Economic Commission for Europe
Inland Transport Committee
World Forum for Harmonization of Vehicle Regulations
Working Party on General Safety Provisions
123rd session

Geneva, 28 March–1 April 2022

**Report of the Working Party on General Safety Provisions on
its 123rd session**
Contents

“ Figure 4
Field of Detection

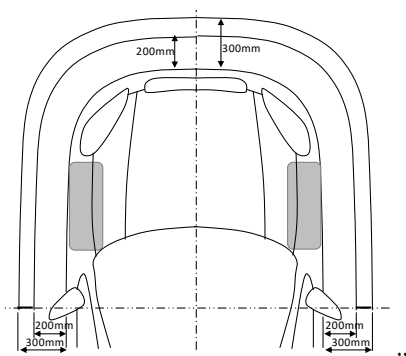
Paragraph 15.3., Figure 4, amend to replace:

“ Figure 1
Field of detection

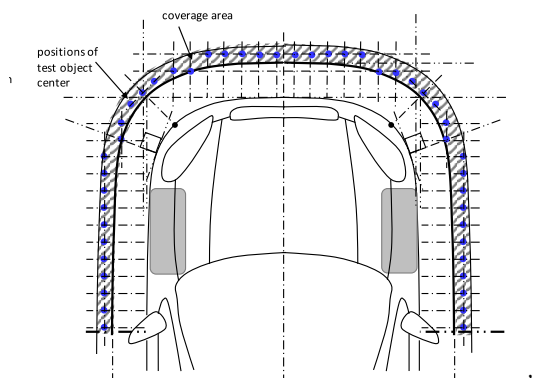
Annex 12, Paragraph 1.3.1., Figure 1, amend to read and replace:
